Subject: Docket Number COE–2010–0007, Response to Public Notice - Process for
Requesting a Variance from Vegetation Standards for Levees and Floodwalls

Our comments are relevant to the River Islands project; a 4,800 acre master planned community within the City of Lathrop, California in which I am the project director. River Islands is surrounded by 12 miles of project levees on the Stewart Tract located within the southern portion of California’s Sacramento-San Joaquin Delta; please see Exhibit 1 (attached). The site is also designated by State law to be within the “Secondary Zone” of the Delta, which allows urban development.

EXHIBIT 2 - STANDARD VERSUS REINFORCED LEVEE

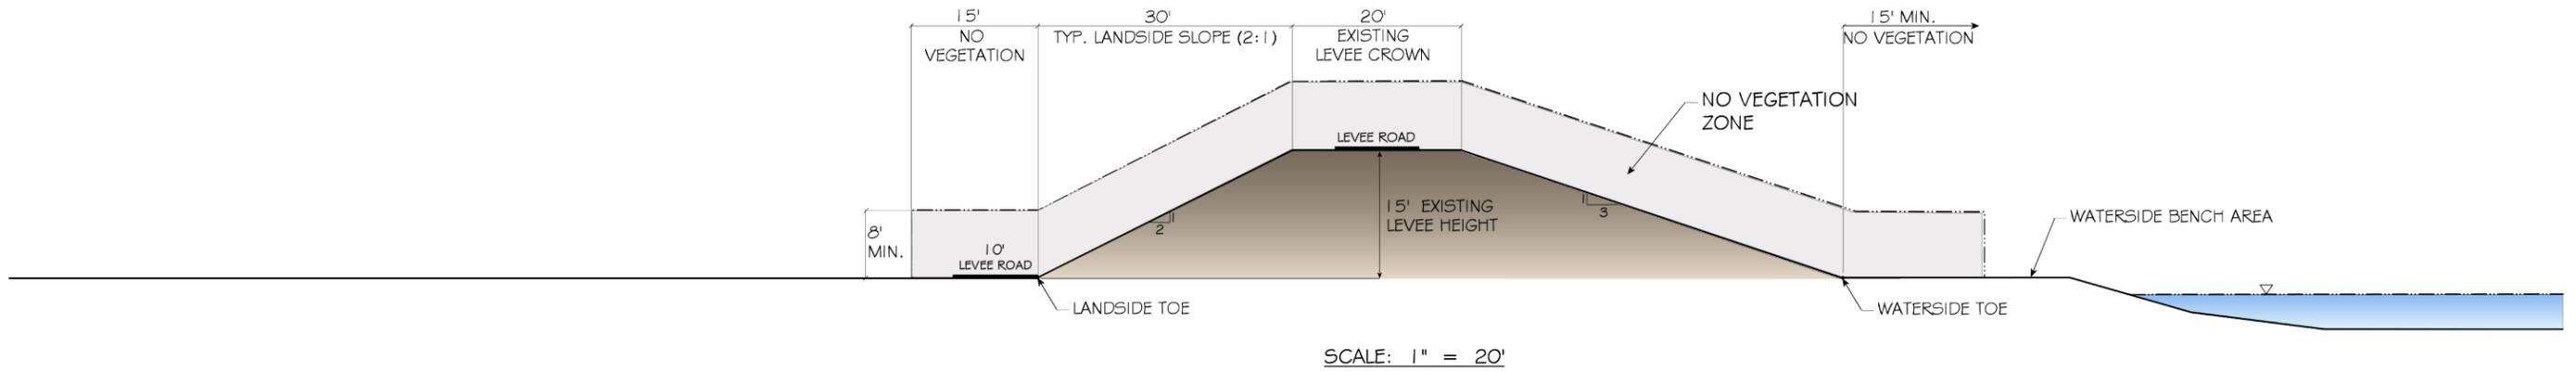
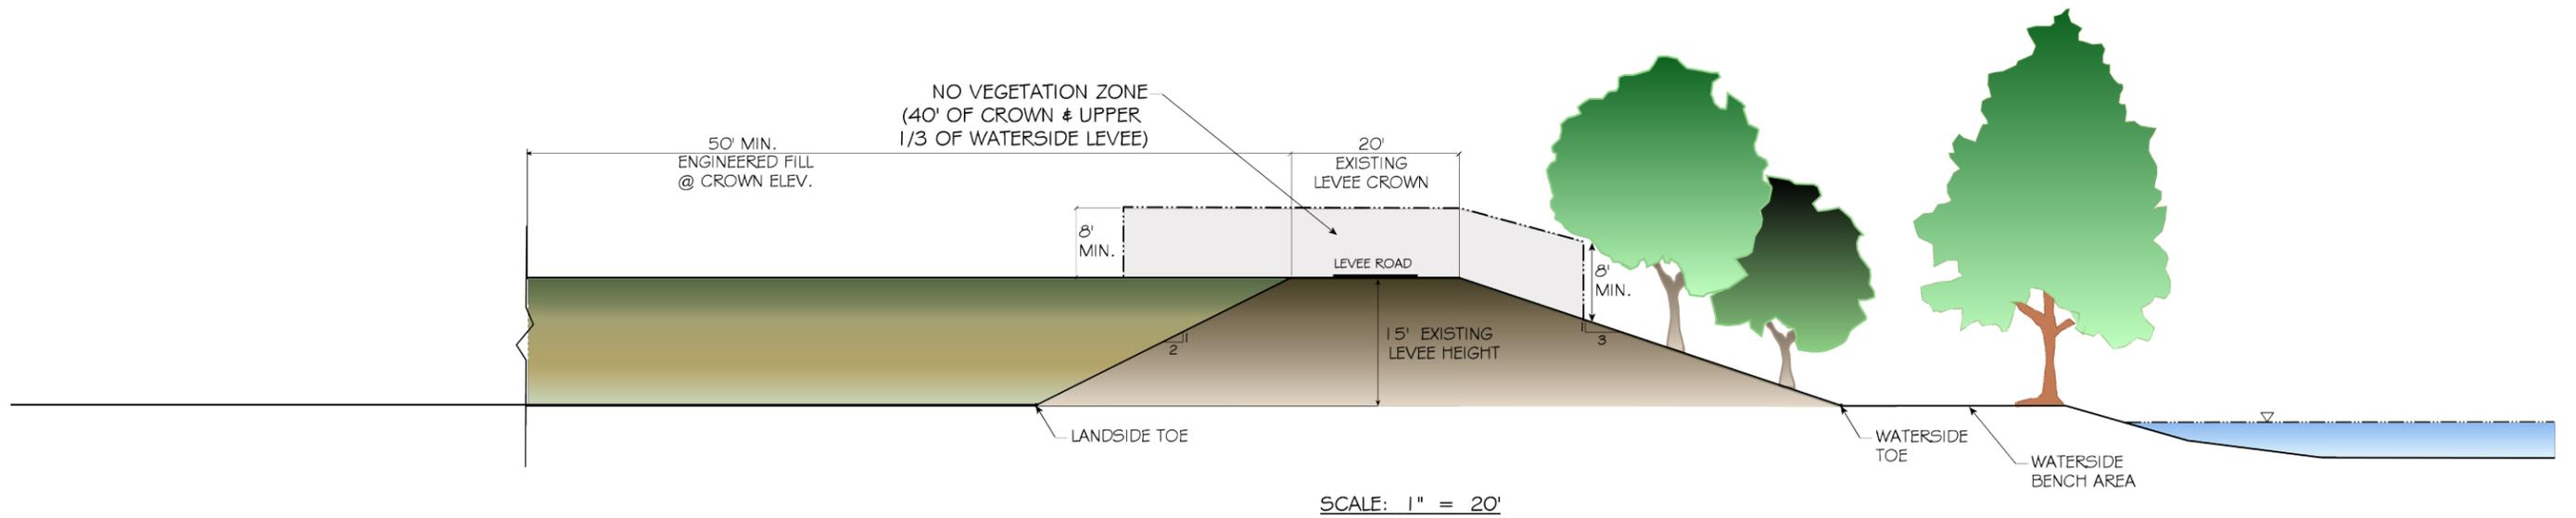
While we appreciate the safety and maintenance concerns associated with vegetation on waterside slopes of *standard* levees, not all levee systems are the same. In this regard, ETL 1110-2-571 and the proposed variance process do not distinguish between a *standard* levee system and a *reinforced* levee system and the applicability of the variance process. For example, Section 5 of the Policy Guidance Letter (see Federal Register at p. 6365) defines a levee system as follows: “A levee system consists of one or more segments and associated features which collectively provide flood, storm, or hurricane damage reduction to a defined area.” (Also see Chapter 3 of ETL 1110-2-571.) While that is true, a standard levee cross section shown as Figure 1 in Exhibit 2 is very different in terms of the nature of the protection and structural integrity afforded than that provided by a reinforced (oversized) levee as shown in Figure 2 of Exhibit 2. Oversized levees provide more open space for maintenance roads and clear zones (when properly planted) thereby retaining accessibility for maintenance, flood fighting and inspection. For example, in the case of a levee system that has a crown width of at least 150 feet, trees and other vegetation with root systems would not cause catastrophic damage due to tree windthrow, erosion, etc., as long as the vegetation is properly planted and maintained. Trees that are planted along the bottom 2/3 of a levee slope that are maintained with at least 8 feet of vertical clearance from grade to branches will provide sufficient viewing corridors for maintenance and floodfighting purposes.

By treating reinforced the same as standard levees, the Corps will hinder efforts to provide riparian and aquatic habitat in areas that would otherwise benefit from such resources without impacting the levee integrity. Consequently, we respectfully request that the Corps revise ETL 1110-2-571 to distinguish standard levees from oversized levees and include a definition of “reinforced levee” in the policy guidance. It should be noted that the California Code of Regulations Title 23 already includes a definition of an “oversized levee” that assumes additional reinforced fill behind a standard levee (included as Section 131(a)(1) of Title 23). The Corp may want to simply incorporate this already vetted definition.

Consistent with the addition of a definition pertaining to “oversized levees,” we also request that the U.S. Army Corps of Engineers (Corps) modify the proposed variance process in Section 6 so that vegetation is permitted on the waterside slope of oversized levees without triggering the need for a variance. We have identified three (3) possible options in clarifying the guidance in this regard. First, Section 6 could be revised to clarify that it applies to levees *other than* an oversized levee as defined in ETL 1110-2-571. Alternatively, ETL 1110-2-571 could be revised to include *an exemption* for vegetation on oversized levees. Third, Section 6 could be revised to allow for a more streamlined process for oversized levees as follows:

EXHIBIT 4 - COMPARATIVE LEVEE CROSS-SECTIONS

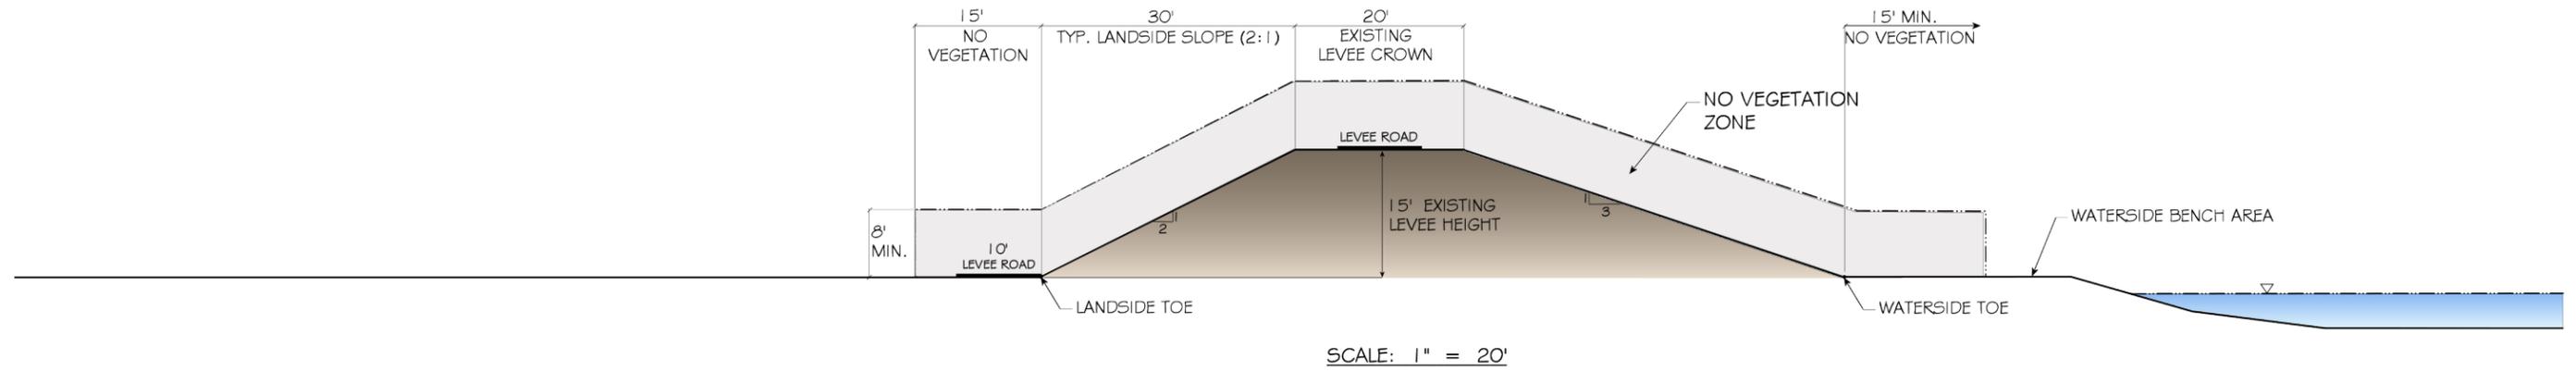
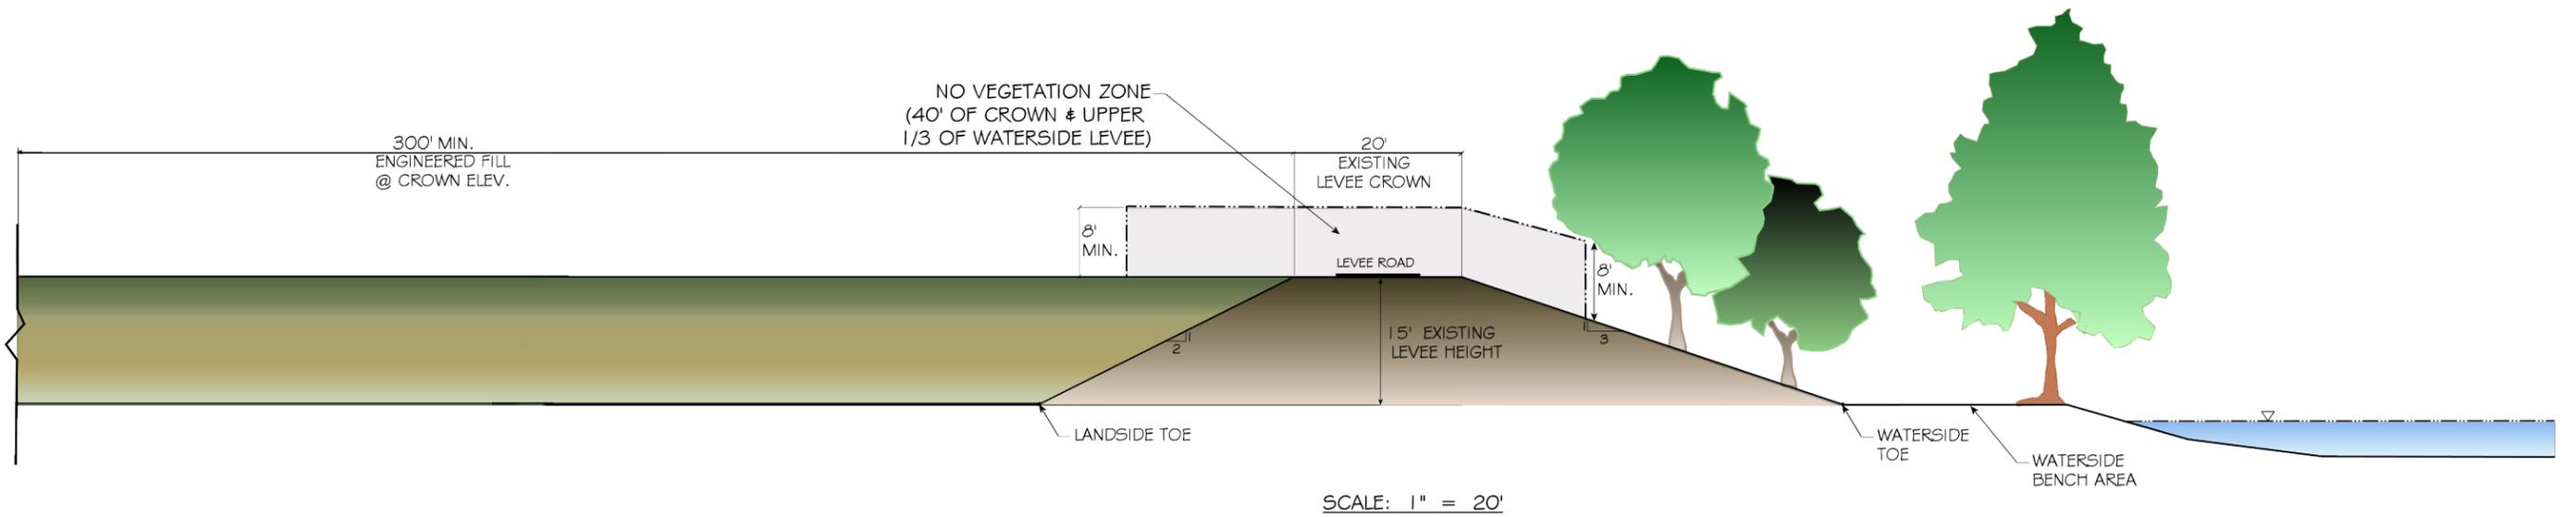
It is also important to understand why such plantings in River Islands’ case would not impact levee stability and maintenance as required by the Corps’ proposed second finding for a variance. The River Islands levee program includes the reconstruction of existing project levees that includes engineered fill against the standard project levee that results in an additional 280 feet of crown width behind the standard 20 foot crown. These “superlevees” meet all FEMA and Corps standards, including those for access, under and through seepage and would allow planting to occur on the waterside of the levee without risk of tree root or rodent undermining due to their extreme width. Extensive technical analysis has been undertaken to ensure the stability and structural integrity of the levee system would be maintained should trees become windthrown or otherwise uprooted from levee slopes. Further, all trees planted by River Islands on the waterside levee slopes would be outside the root-free zone as prescribed by the Guidance. Our

geotechnical consultant, Engeo, Inc. has provided a technical letter regarding the superlevee's stability while vegetated; please see Exhibit 3. We have also included a comparison of our superlevee cross section with a typical project levee with the attached Exhibit 4. This exhibit illustrates the significant fill placed behind the existing levee prism.

FIGURE 8.10 - TITLE 23 CALIFORNIA CODE OF REGULATIONS

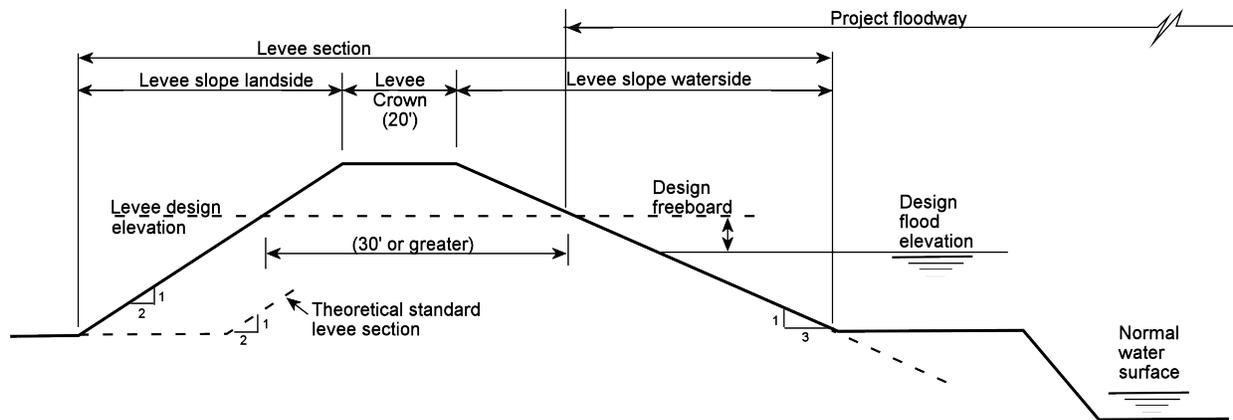
We have already completed a significant portion of superlevees in our Phase 1 area of the project. These levees already achieve a 200 year level of flood protection for approximately 900 acres of the project site. Plantings on these already-constructed superlevees were contemplated to occur under State law (see e.g., Cal. Water Code §§ 8571, 8608-8610). In this regard, current State of California regulations contained in Title 23 of the Code of Regulations (the regulations enforced by the State of California's Central Valley Flood Protection Board) allow for the planting of certain trees, shrubs and groundcovers on levee slopes defined by the State as "oversized levees." Section 131(a)(1) of Title 23 specifically states that, "an oversize levee means a levee which encompasses the minimum oversized levee cross-section which has a width of thirty (30) feet at design freeboard elevation and standard levee slopes," (See Exhibit 5 attached). As noted, River Islands' levees will be at least ten (10) times the minimum width required by the State of California to allow such plantings.

River Islands Levee Easement

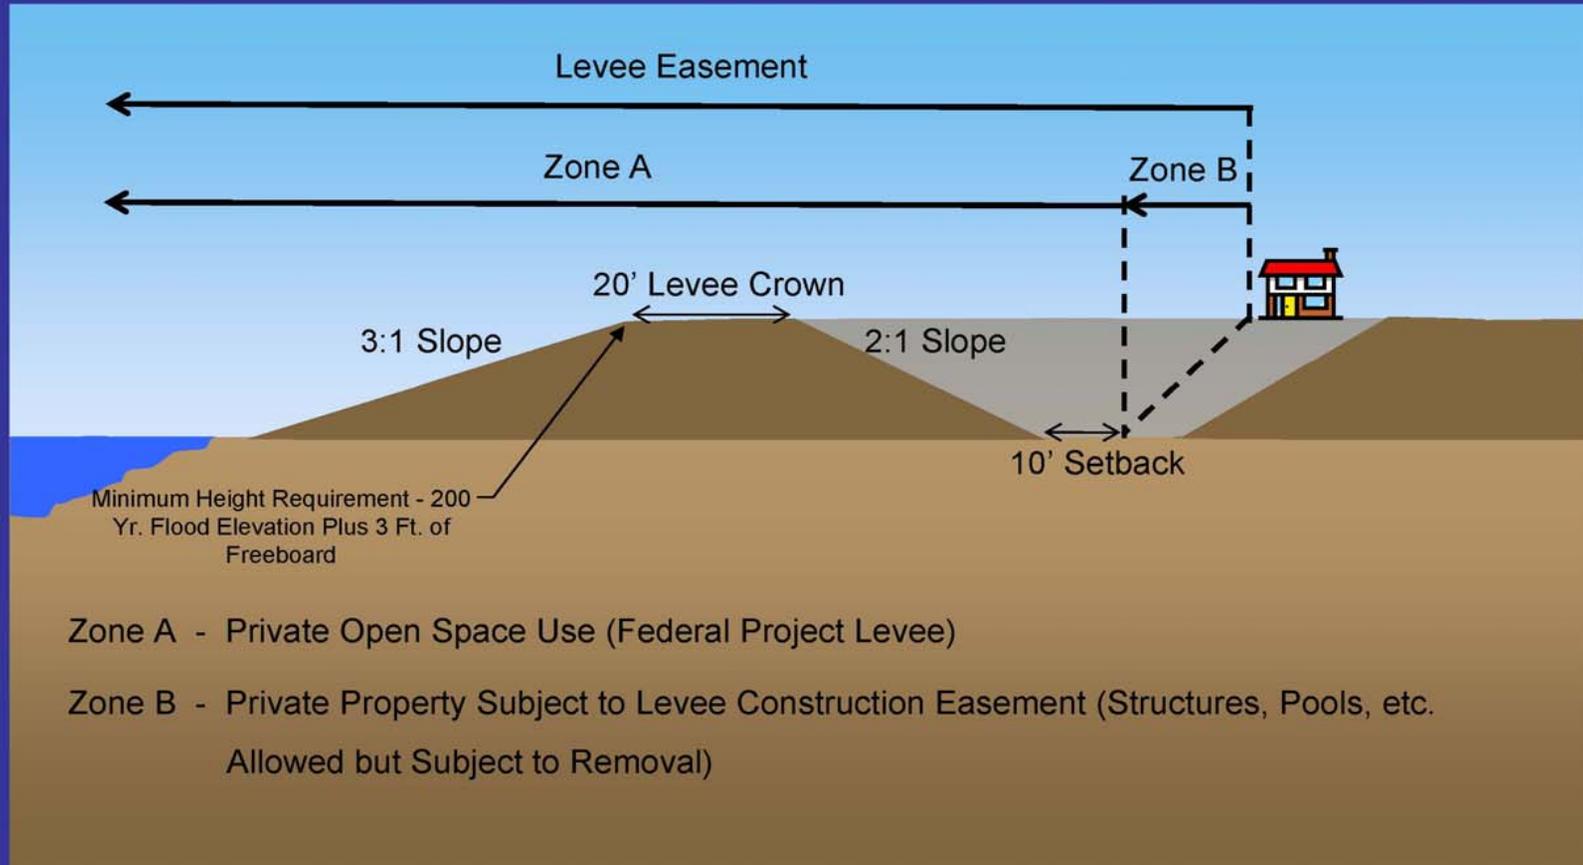
Moreover, the Central Valley Flood Protection Board approved construction of the Phase 1 superlevees with an easement for the placement of structures and other encroachments that is unique to the superlevee (please see Exhibit 6). This "Easement Plan" (known as Zone A and Zone B) allow for the original Federal project levee prism to remain in place and be fully accessed and protected during a flood fight. This particular Easement Plan ensures that accessibility for maintenance; inspection, monitoring, and floodfighting are retained. We believe that the easements for encroachments approved by the CVFPB provide successful examples of levee systems that provide adequate flood protection while affording opportunities for aquatic habitat and should be adopted by the Corps for all widened and reinforced (oversized) levee sections such as ours.

Figure 26: Oversized Levee Section.

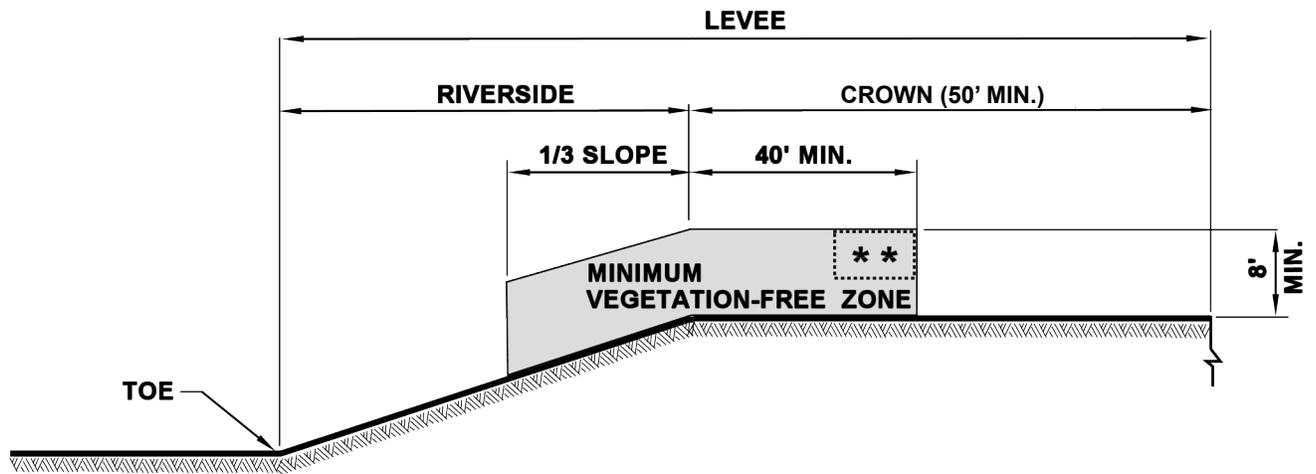
Based upon the information provided in this letter, we respectfully request that the Corps modify its Guidance to clarify that vegetation on the waterside Federal project levee slope may be permitted for oversized levees without the need for a variance. Accordingly, we request that the Corps consider allowing the vegetation of waterside project levee slopes under the circumstances described for our project without a variance. We believe that the extreme width and advanced technological construction of our superlevee system meets the intent of Corps Guidance, including ETL 1110-2-571, since it would not allow roots or other invasive vegetation to undermine the core structure of the levee system and still provide for the protection, restoration and creation of a vital natural resource. As a result, we would suggest changes to the Guidance as shown in the attached Exhibit 7.

d. The minimum vegetation-free zone for oversized levees (as illustrated by Figure 26, Chapter 2) shall be as follows:

(1) The minimum height of the corridor shall be 8 feet, measured vertically from any point on the ground.

(2) The minimum width of the corridor shall include the upper 1/3 of the waterside levee slope (as measured from the waterside levee toe) and a minimum of 40 feet landward from the waterside crown hinge point (as shown on Figure 26).

(3) No vegetation, other than approved grasses, may penetrate the vegetation-free zone, with two exceptions, as illustrated in Figure 2:
